**Proposed Development  
SOPA Site,  
Wentworth Point.**

**Transport Impact Study  
Addendum**

September 2014

Job title:	SOPA Site Transport	Job number
		2013119

Figure 2: Bus Turn Paths - 14.5m Coach.

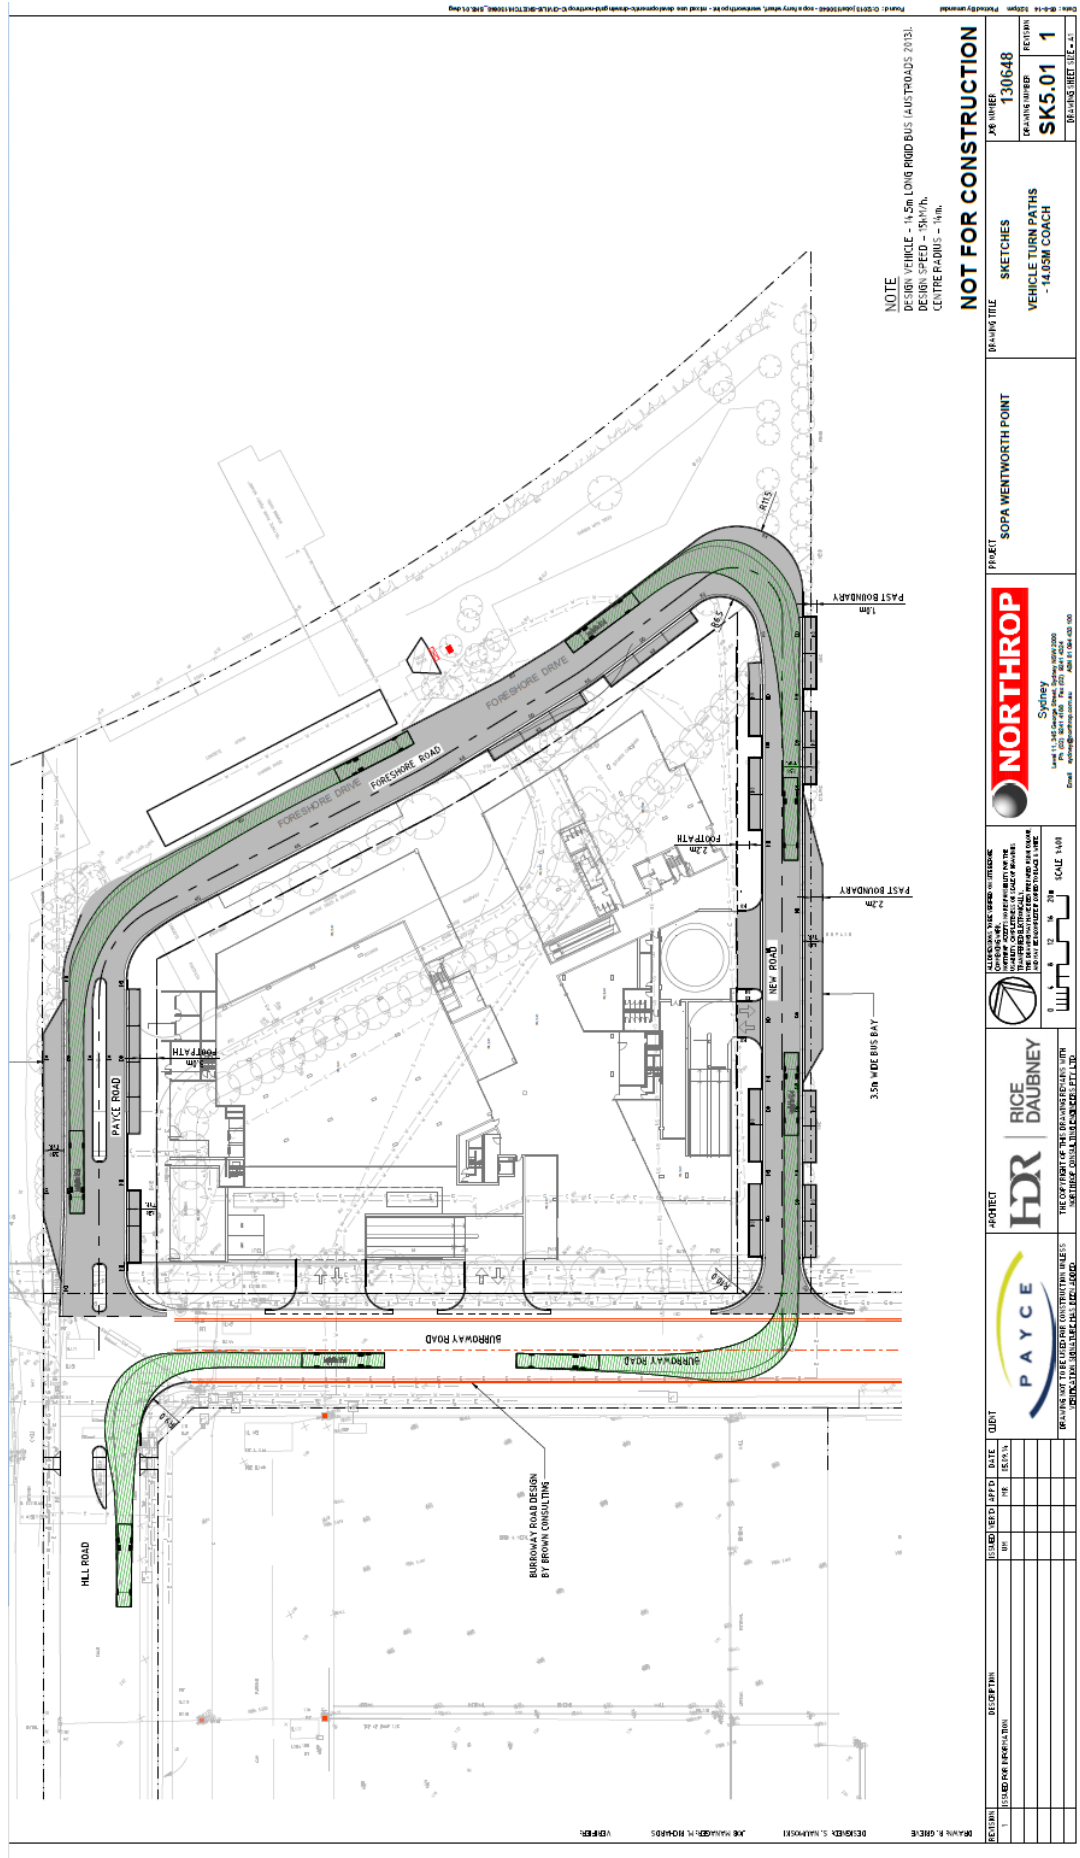
## **2.4      19. The road network must be designed to be accessed by a 14.5m coach for occasional services. Details should be incorporated in the design.**

### **2.6 20. The landscape plan shows the eastern road as a future road. Another plan shows a temporary road to the north, with a cul de sac at its end.**

### **2.8 22. The plans also show a 3m wide section of this road (road verge) on the school site. Council's representative on the Project Control Group for the school advises that the Department of Public Works has stated that the school boundary is the SOPA boundary, and that the road carriageway will be fully provided within the SOPA site.**

### 2.13 25. The road widths are inadequate. On street parking is shown at 2.1m. 2.3m is required in accordance with the relevant Australian Standards

Agreed. The Civil Engineering Drawings (SK5.01) demonstrate that the currently proposed road network is designed to be accessed by a 14.5m coach for occasional service.

See current plans, for example Figure 2 above.

It is understood<sup>4</sup> that the school authorities have undertaken to allow the road to extend 3m within the school site, as shown in Figure 2.

The effective width of parking bays is also influenced by the width of the adjacent travel lanes. As shown in the Civil Drawings including figure 2 above, the on-street parking bays have been widened to 2.3m wide. This is considered generous.

Figure 4: MRV Turning circle for Retail Dock

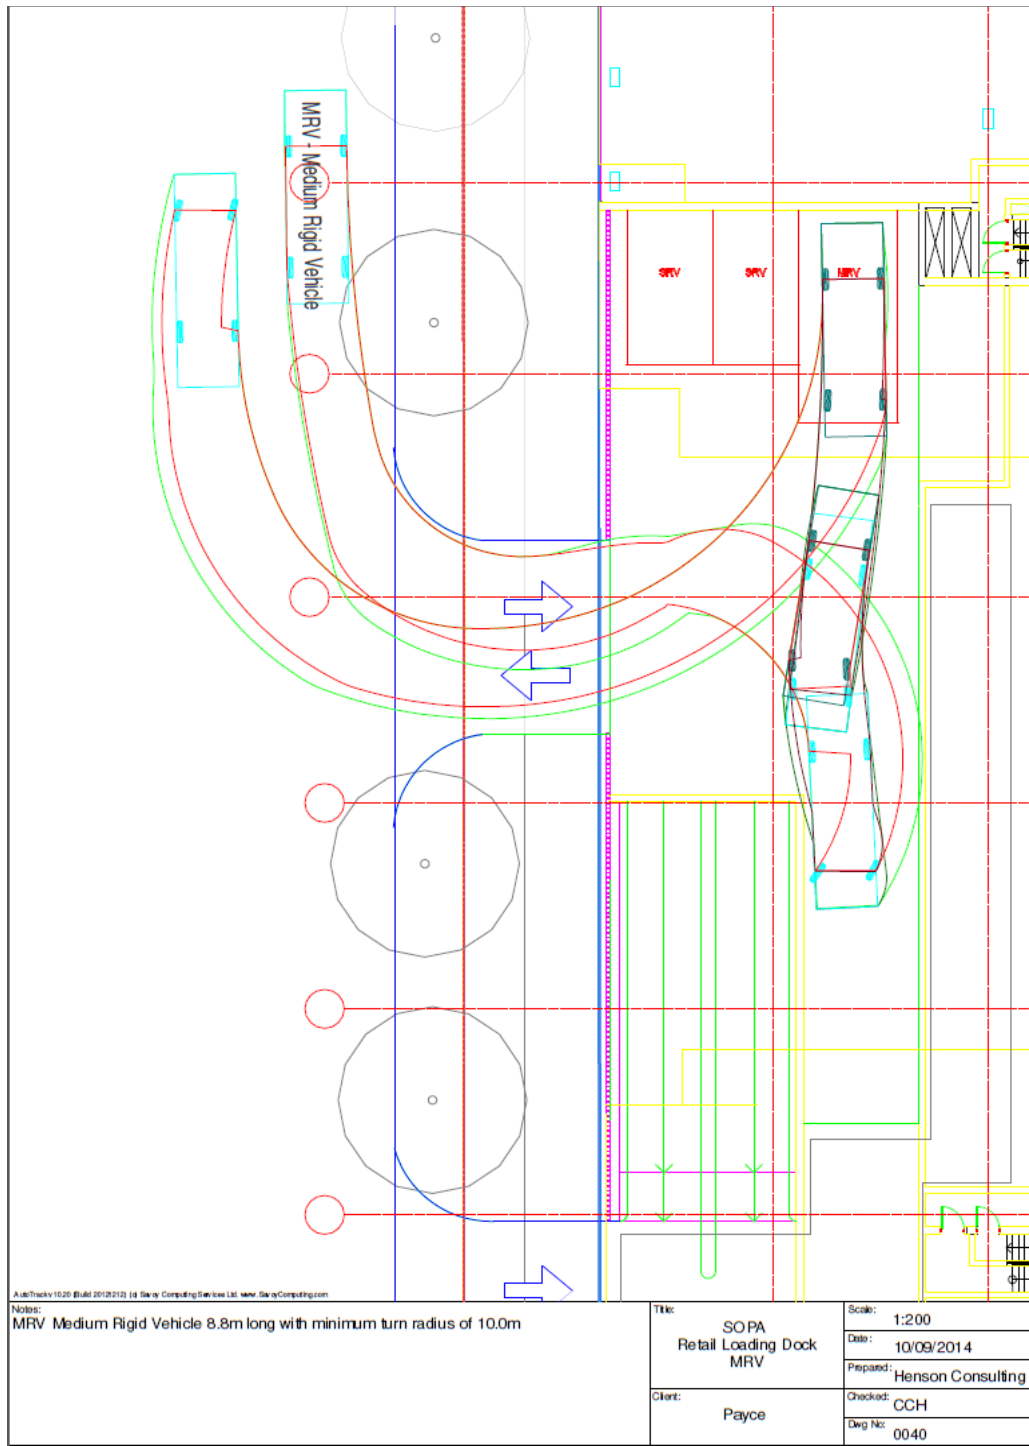
**2.19      33. The submitted traffic report indicates that there will be two loading bays (HRV & MRV) for the retail area. The submitted plan does not indicate the two loading bays. Two loading bays should be shown on plan with appropriate turning circles to ensure that both can function independently.**

The revised scheme provides bays for one retail MRV and two retail SRV's in the Retail dock off Burroway Road, and one MRV waste vehicle on a turntable accessed off the New Road. Turning circles as shown as follows.

Figure 5: MRV Turning circle for Waste Dock turntable.

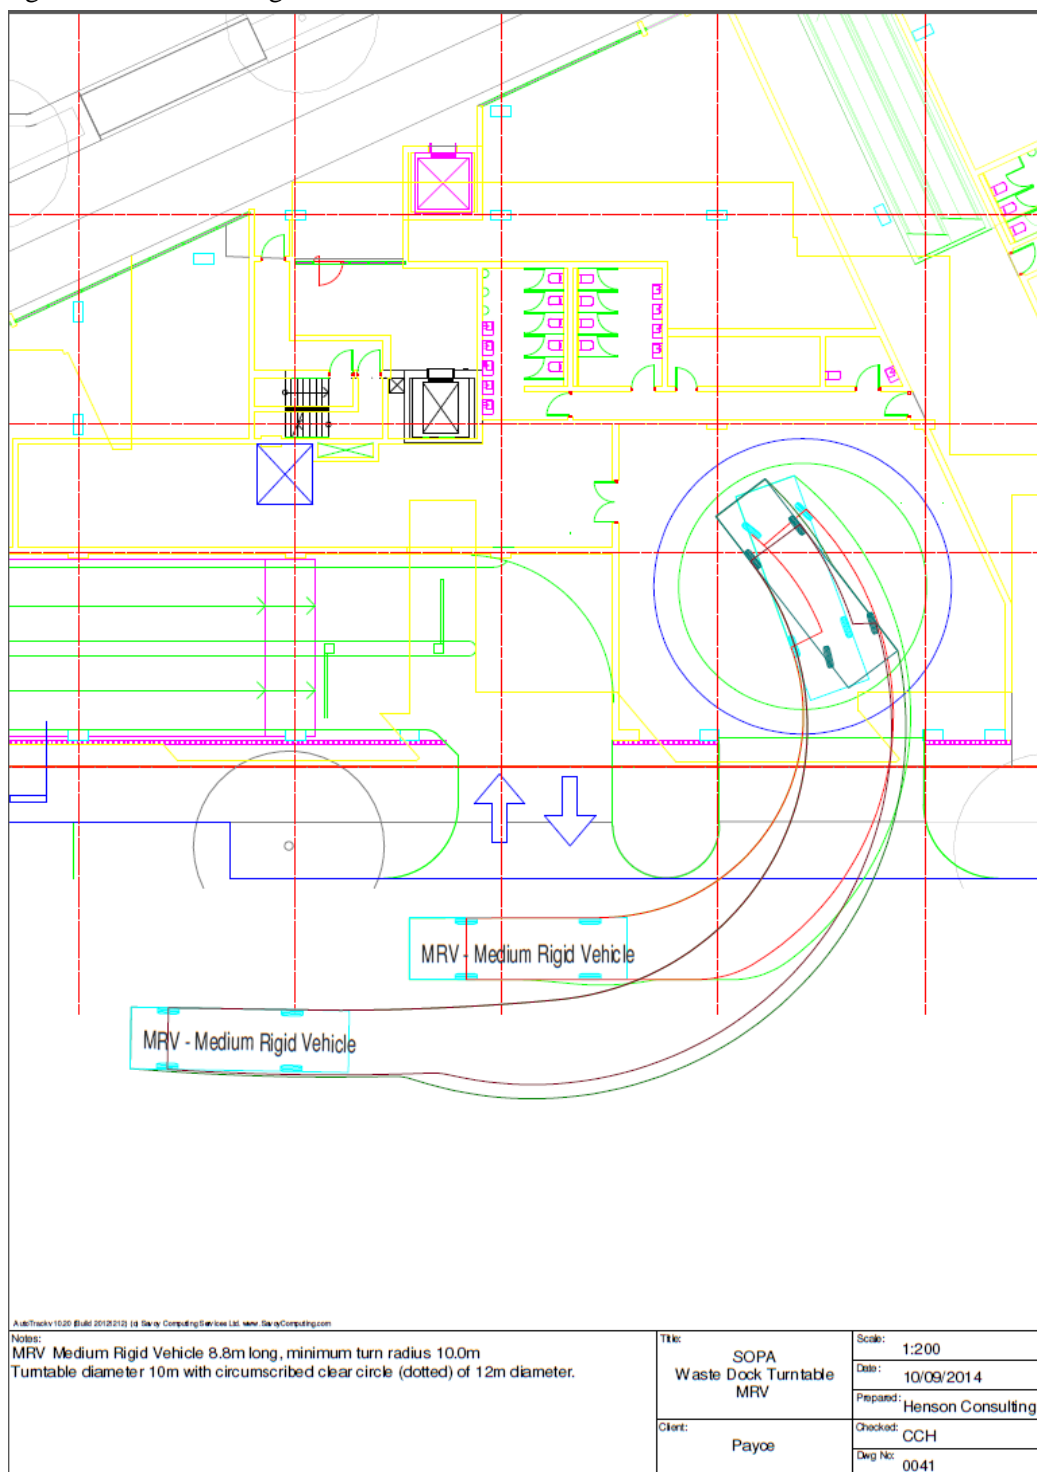
- 2.29 53. Council has concerns about the location of the main waste handling room so close to the vehicular access to the development. Council's position is not (as stated in the EIS) that waste collection is to be on road. Rather, Council seeks on-site waste collection.**

- 2.31 54. Waste must be collected on site. Council has consistently applied this requirement in all recent developments in the Wentworth Point precinct. The planning report indicates that Council was consulted about this. Council does not object to collecting the garbage at street level provided: • The collection vehicle can be within the development site while loading; • The collection access point to the development is via the new proposed road, and • A minimum 4.0 m head room is required.**

The revised scheme provides on-site waste collection. The residential waste dock is operated using a truck turntable in a waste dock off the New Road. The retail and commercial waste dock is off Burroway Road.

The proposed waste loading dock satisfies these requirements.

Figure 10: Sightline analysis

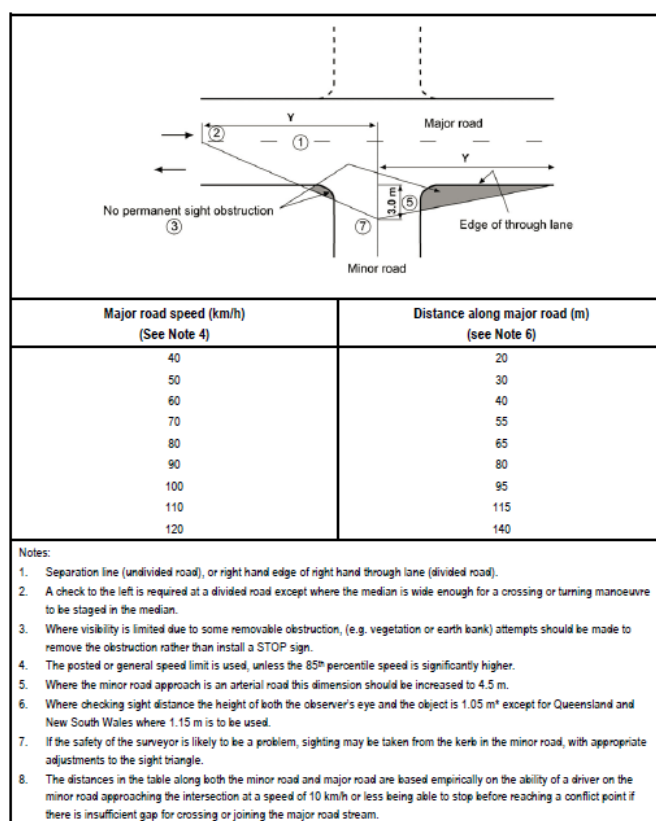
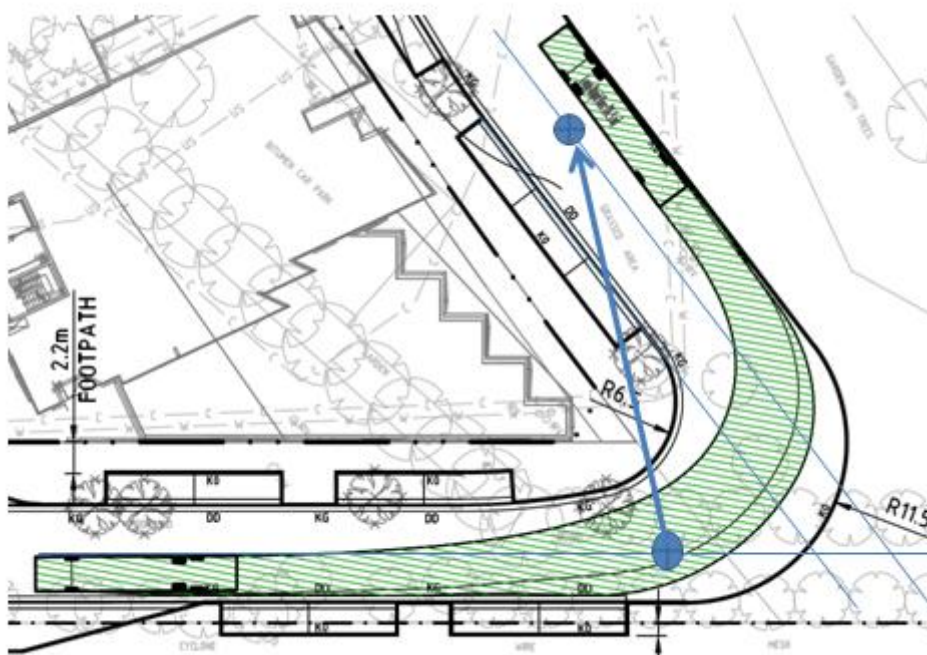
**6.16 New Road As with Foreshore Drive, TfNSW has concerns with the proposed design of New Road. This road will provide access and egress to all vehicle and bus movements to the ferry wharf, as well as commuter bus services, school drop off/pick up, and residential traffic. • TfNSW notes that the design of New Road does not appear to be consistent with the Wentworth Point Precinct Master Plan (see Attachment 3), in providing the necessary width of carriageway and parking. o It is recommended that the design of the road be amended to comply with the Master Plan, also taking into account necessary lane widths for roads to accommodate buses (being a minimum of 3.5m). o The Master Plan necessitates the New Road corridor to be 16m wide, comprising 13m on the subject development site and 3m**

**on the adjacent Maritime site. • TfNSW advises that New Road should have a parking lane along its eastern side to accommodate a school pick up/drop off zone of adequate size and sufficient space for two 14.5m non-rear steer buses including draw in/out. • The width of this parking lane should be a minimum of 3.5m. This would remove any impediment to buses using the travel lane on New Road, caused from school buses overhanging in the travel lane. • Kiss and ride facility patrons must access the facilities via New Road. Therefore, way finding signage should be provided to direct patrons of the kiss and ride facility to turn right into Burroway Road from Hill Road when approaching from the south.**

Note that the corner of Foreshore Drive and New Road is not strictly an intersection, but rather a sharp bend in a continuous road with no intersecting roads or local driveways etc but there may be some bus and car parking and unparking manoeuvres close to the corner. there is no pedestrian crossing either: pedestrians should cross Foreshore /Road at the ferry wharf or cross New Road at Bennelong Road. As such the Austroads requirements<sup>6</sup> apply of : *provide adequate warning of the presence of the intersection or crossing through clear sight lines and/or appropriate signage and provide adequate sight distances between conflicting road or rail users*

However, application as shown in the following diagrams of intersection Stopping Sight Distance as per Austroads Figure 3.2 sight distance restrictions requiring use of stop signs with a major road speed of 50km/h (worst case) on Foreshore Drive and consequent distance along major road of 30m, from a viewpoint 3m back on the centreline (in this worst case , choose property line extended ) of the New Road, there is no permanent sight obstruction to approaching traffic on Foreshore Road centreline. Childcare fence sightlines should not be an issue.
